GROUP	MODEL
Customer Satisfaction	2025MY Carnival (KA4) EX, SX, SXP
NUMBER	DATE
CS2401	October 2024

TECHNICAL SERVICE BULLETIN

CUSTOMER SATISFACTION: DOOR TRIM ASSEMBLY REPLACEMENT (CS2401)

Replacement Procedure: (Front)

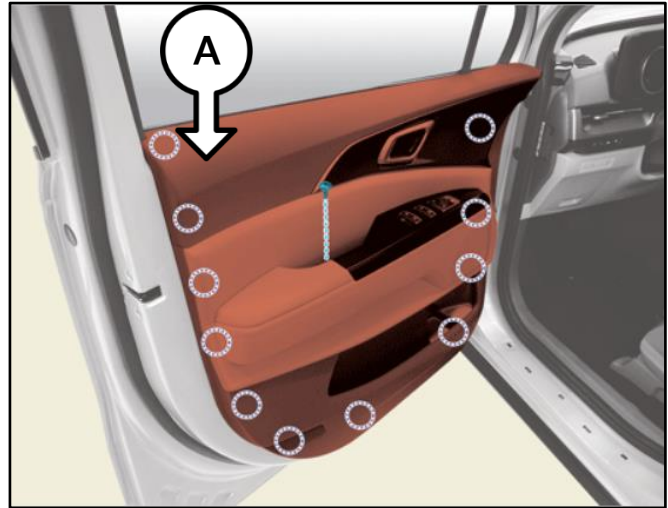
This bulletin provides information to replace the front and rear door trim assemblies on certain 2025MY Carnival (KA4) EX, SX, SXP vehicles produced from April 16, 2024 through May 24, 2024. Since the production of the subject vehicles, Kia has made a production change to the door trim color and is making that color available at no charge to those customers who elect to have the door trim color changed. Follow the procedure outlined in this publication to replace the front and rear door trim assemblies on the applicable vehicles. Before conducting the procedure, verify that the vehicle is included in the list of affected VINs.

1. Disconnect the negative (-) battery terminal.
2. Replace the left and right front door trim assembly (A) by referring to "Body (Interior/ Exterior/Electrical) → Door - Front → Front Door Trim → Removal and Installation" in the applicable Shop Manual on KGIS.

3. Reinstall all removed parts in reverse order of removal.
4. Confirm normal operation.
